SCOPE OF WORK

-CONVERSION OF EXISTING COMMERCIAL OFFICES TO A 2 FAMILY DWELLING
-GUT RENOVATION OF INTERIOR OF BOTH UNITS.

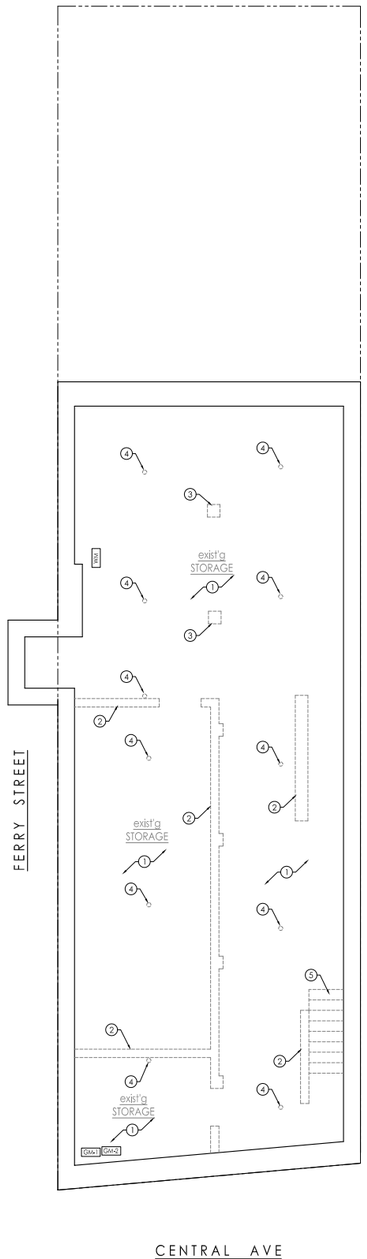
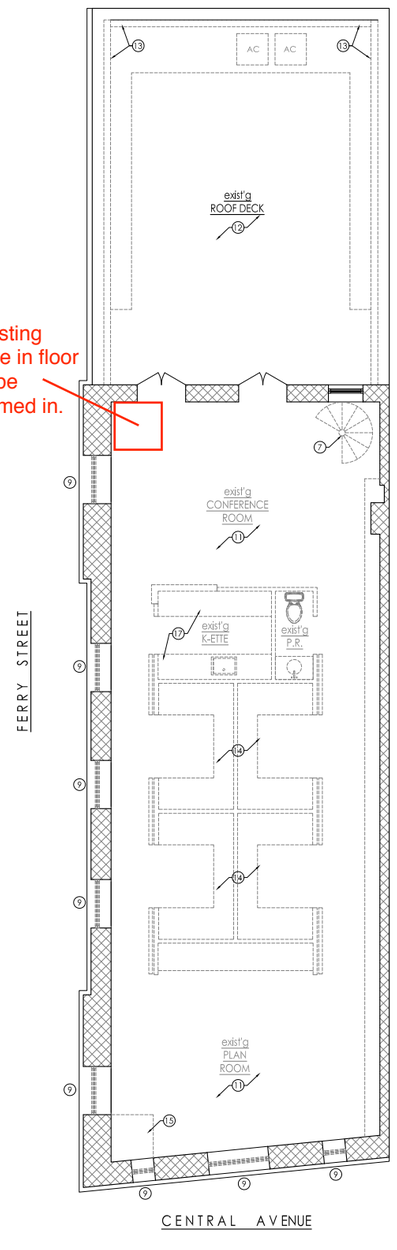
all original interior window casings to remain

Need to verify, but I think this holds true for base molding as well, TBD

2 1ST FLOOR DEMOLITION PLAN
3/16" = 1'-0"

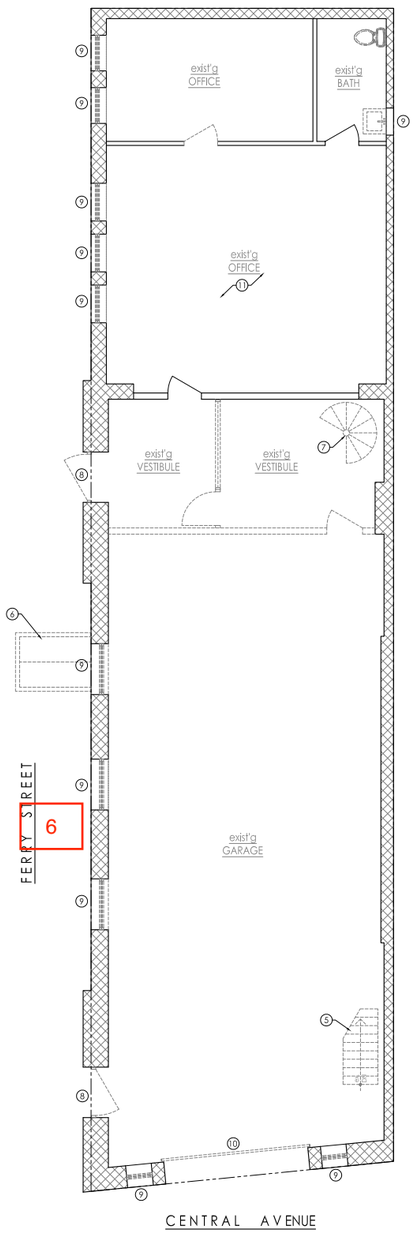
Do we need a note about moving condensors to upper roof?

existing hole in floor to be framed in.

1 ROOF DEMOLITION PLAN
3/16" = 1'-0"

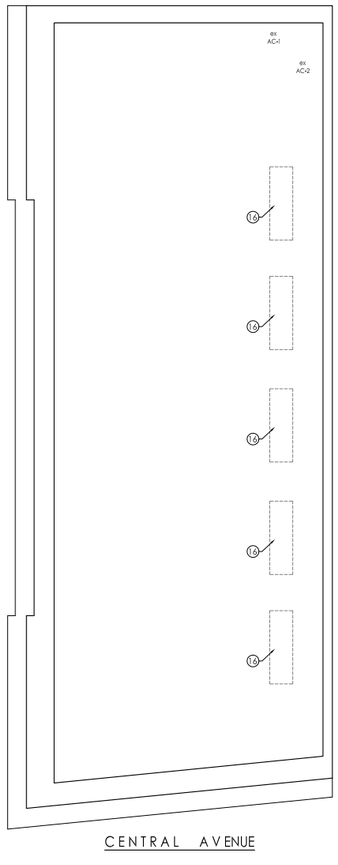
Note about removing all existing wiring and panels. Start fresh.

Do you think that is necessary, or over kill?

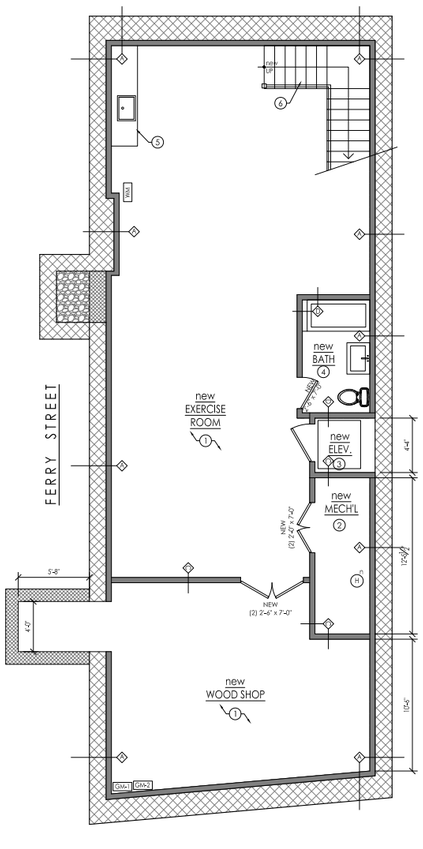
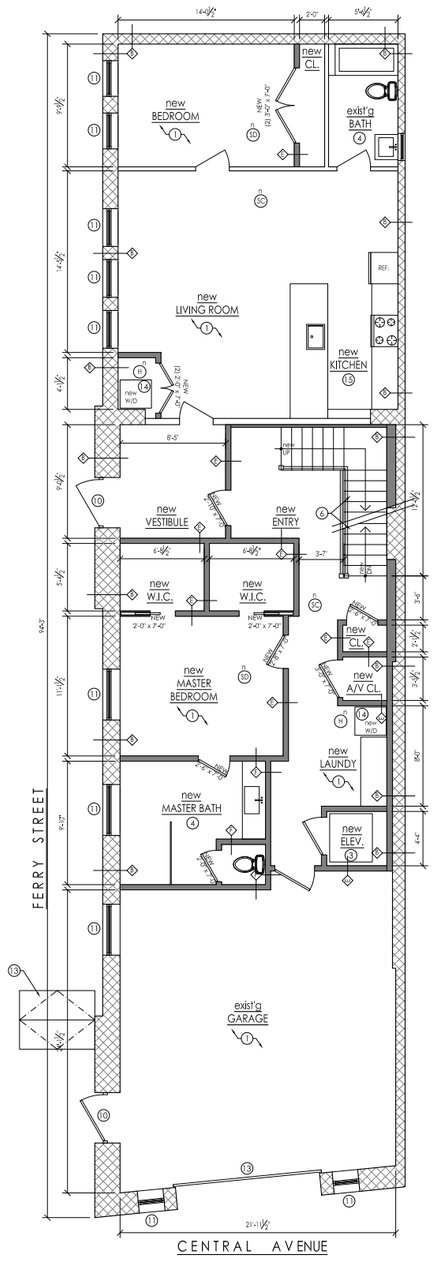
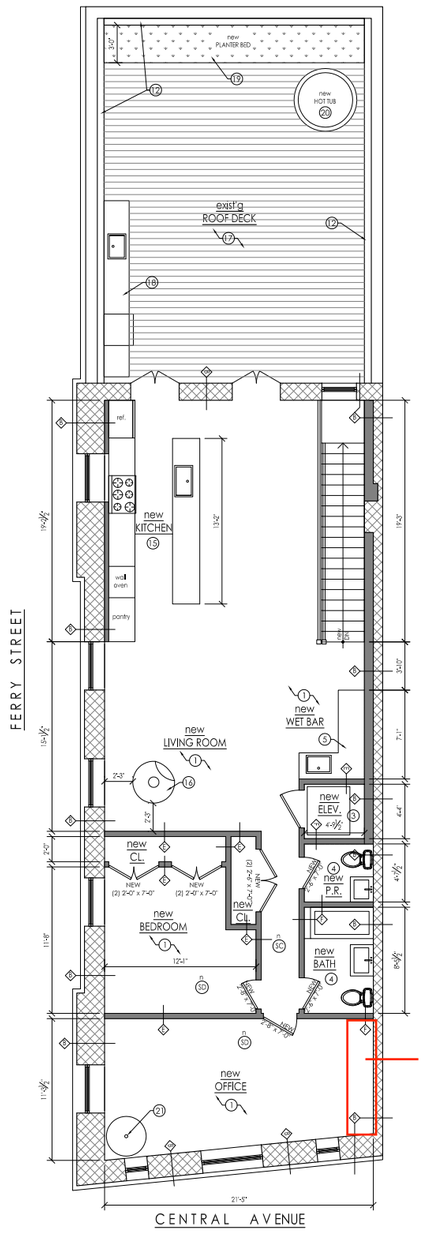
Re-Install section of existing floor to ceiling shelving

For clarity, ALL shelving to be removed during demo, as I want to use a different section in my office that will accomodate file cabinets

note should also state these need to be carefully removed and not destroyed

1 PROPOSED CENTRAL AVENUE ELEVATION
1/4" = 1'-0"

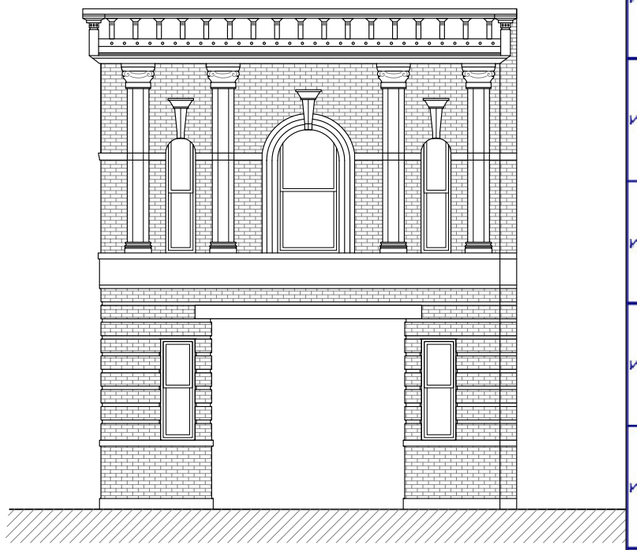
Note of window schedule from my last email:

I noticed you used my window schedule. Please note, while all of the dimensions are correct, none of the windows are actually curved at the top. The windows are standard double hung and get installed behind the arch in the brick facade. Renewal by Andersen is aware of same and I have a site visit with them to field verify all on 3/27, but being as we are on National Historic Register, and have to go before historic, I want to make sure we are accurately representing the windows, as I know they are a stickler on this item.

2 PROPOSED FERRY STREET ELEVATION
1/4" = 1'-0"

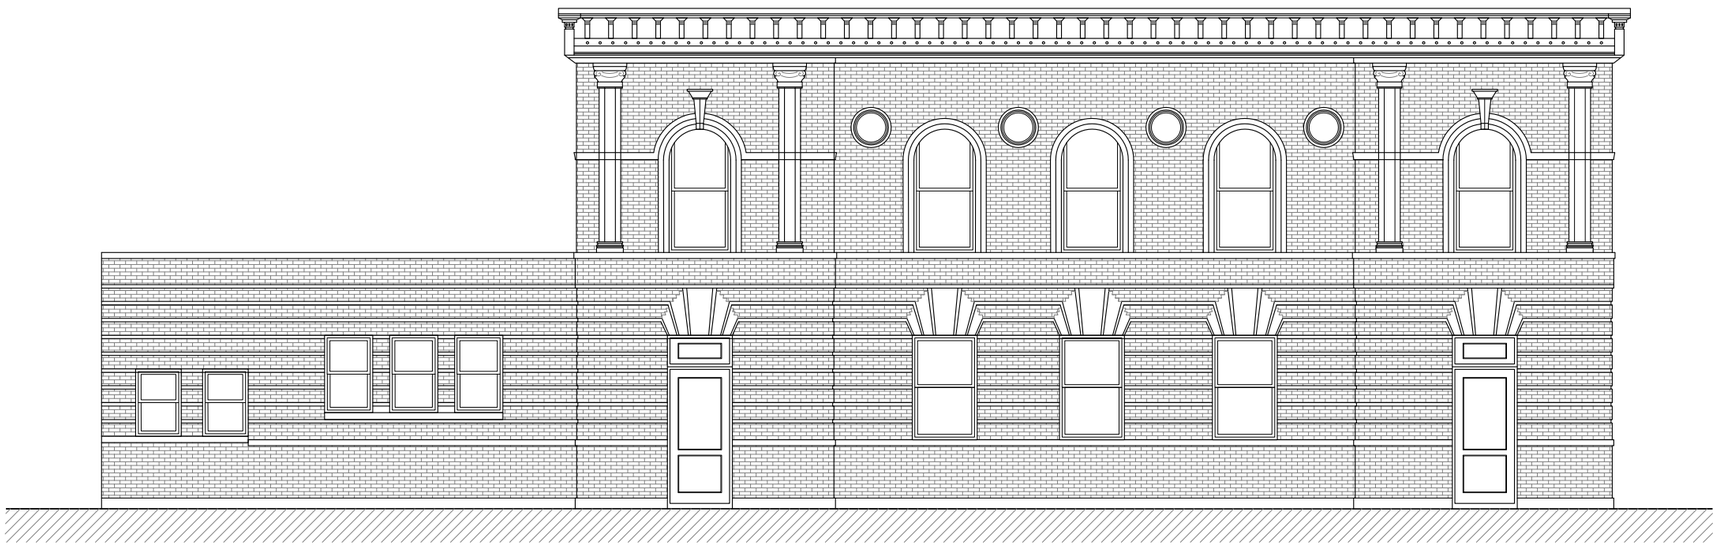
I need more time with this sheet in order to cross reference all properly, but don't want to delay progress with all other notes.

5 UNDERPINNING SEQUENCE
N.T.S.

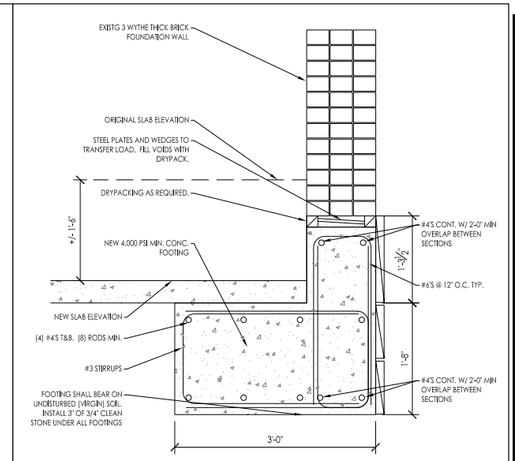
Can we do A-C-E-B-D?
Does this plan show a French Drain as well? there is a lot of ground water, and my father seems to remember something about a natural spring…not sure, or is 4" gravel enough?

1 SANITARY AND STORM DRAINAGE RISER DIAGRAM
N.T.S.

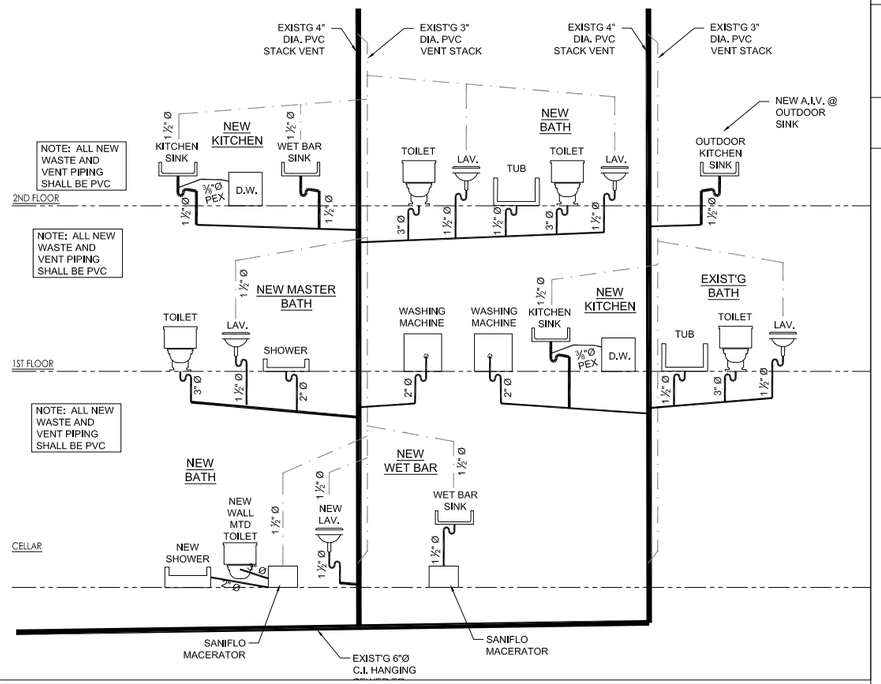
Do we need to show upper and lower roof drains here?

3 GAS RISER DIAGRAM
N.T.S.

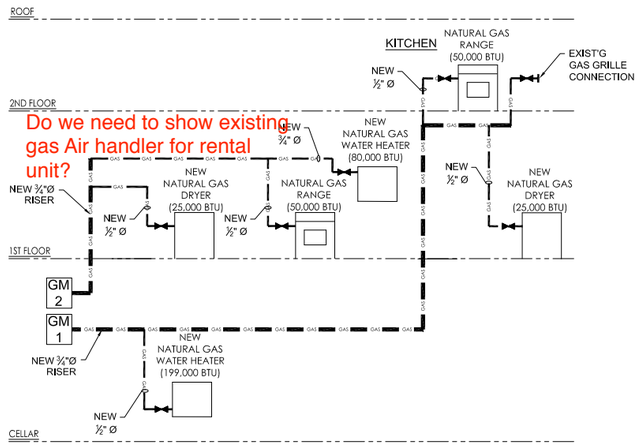
Do we need to show existing gas Air handler for rental unit?

2 PLUMBING SUPPLY RISER DIAGRAM
N.T.S.

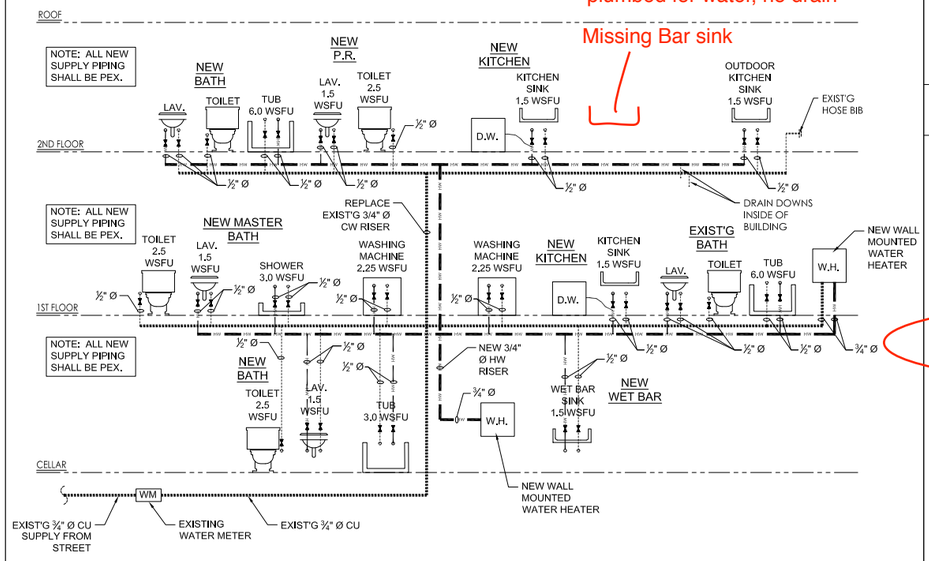
Coffee Machine will also be plumbed for water, no drain

Missing Bar sink

Pex
